**Customer Advice Note  
CAN #142**

**Galaxy RIO C072  
Jumpers**

**Date: August/2021**

C072

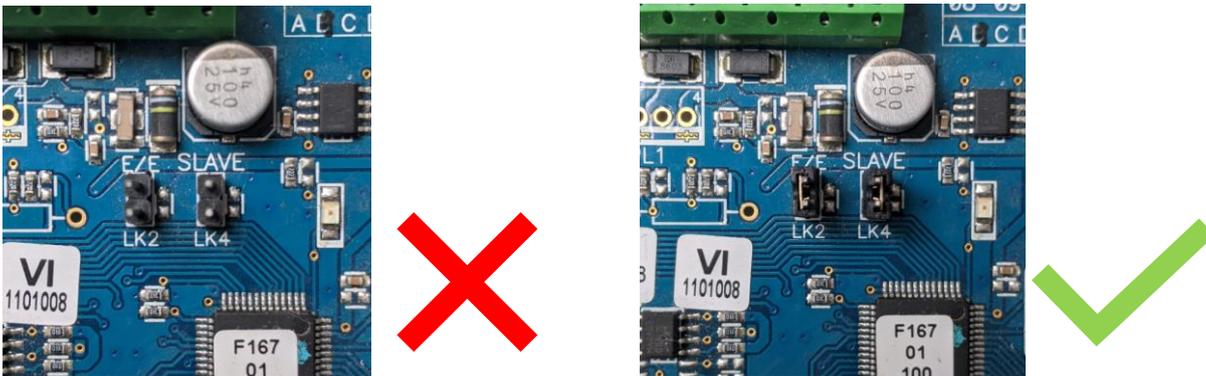
This Customer Advice Note details a problem with the Galaxy RIO (**C072**) Jumpers  
A number of the Galaxy RIO have shipped with the jumpers **LK2** and **LK4** open on the PCB.

When LK2 and LK4 are removed the RIO is configured for a standalone feature which is not compatible with connection to a Galaxy control unit. Enrolment of RIO in this configuration results in the zones being unresponsive.

Remove the Galaxy RIO (**C072**) unit from the cardboard giftbox. (Retain any fixings and packaging)  
Locate the **LK2** and **LK4** Jumper terminals on the PCB. These Jumpers should be in a closed position.

Please fit 2 Jumper links to close **LK2** and **LK4** as per picture above.

**NOTE: If RIO is added to the system please remove from the RS485 and re-add with Jumpers pre-fitted.**
